# Vibration at Idle in Park

YEAR(S)	MODEL(S)	ADDITIONAL INFORMATION
2015 - 2017	NX200T

Some 2015 – 2017 model year NX 200t vehicles equipped with 8AR-FTS engines may exhibit an abnormal vibration at idle in Park. The Engine Control Module/ECM (SAE Term: Powertrain Control Module/PCM) logic has been modified to reduce the possibility of this condition occurring. Follow the Repair Procedure in this bulletin to address this condition.

**Figure 1. Location of Authorized Modifications Label on 2015 – 2017 NX 200t**

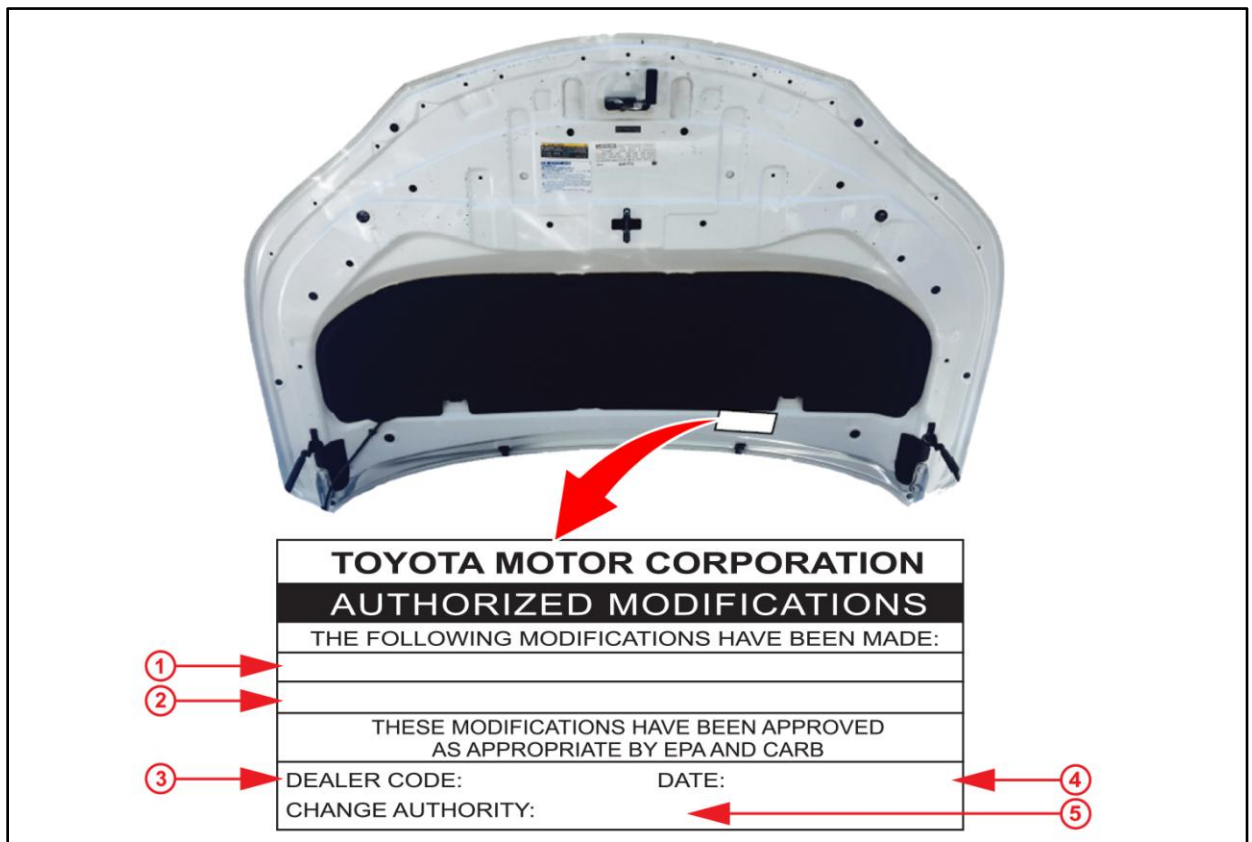
- Check for the Authorized Modifications Label affixed to the vehicle in the location shown below. Confirm if the ECM (PCM) calibration has been updated.

- Prepare and install the Authorized Modifications Label.
  - Using a permanent marker, enter the following information on the label:
    - ECM part number [Refer to the **Parts Information** section for the **NEW PART NUMBER**]
    - Calibration ID(s) [Refer to the **Calibration Information** section for the **NEW CALIBRATION ID**]
    - Dealer Code
    - Repair Date
    - Change Authority [**This bulletin number**]
  - Install the Authorized Modifications Label to the vehicle at the location shown in Figure 1. The Authorized Modifications Label is available through the MDC, P/N 00451-00001-LBL.
- Verify the vibration condition is no longer present.
